**ENGINEERING CHANGE REQUEST (ECR)**

CUSTOMER DRAWING NO. D 972397

DRAWING TITLE BSC BELLOWS REMOVAL JIB CRANE ASSY

REVISION: FROM A TO B

972397

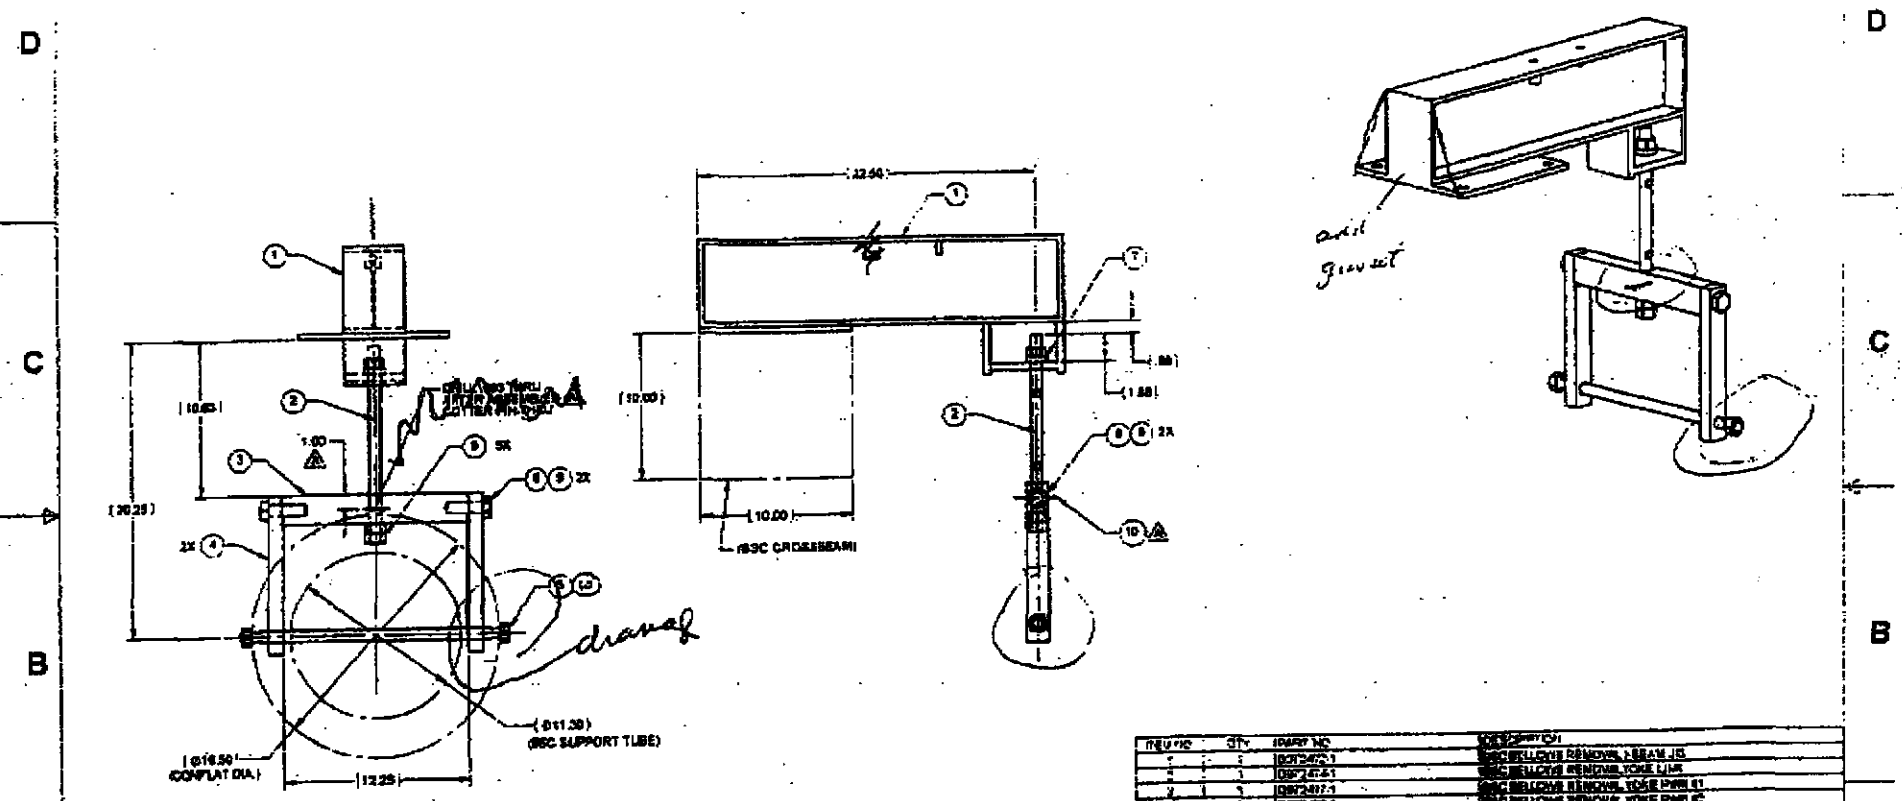
- ① ZONE 7C REMOVE COTTER PIN CALL OUT ② SHORTEN
- ITEM 5 ③ SUBSTITUTE  $\frac{3}{16} \times \frac{1}{2}$  LG. COTTER PINS FOR 2 OF ITEM 6
- ④ ADD GUSSET PER D972472 ECR ⑤ ZONE 5C DELETE BOSS.

CUSTOMER REQUEST & STRENGTHEN MOUNTING PLATE
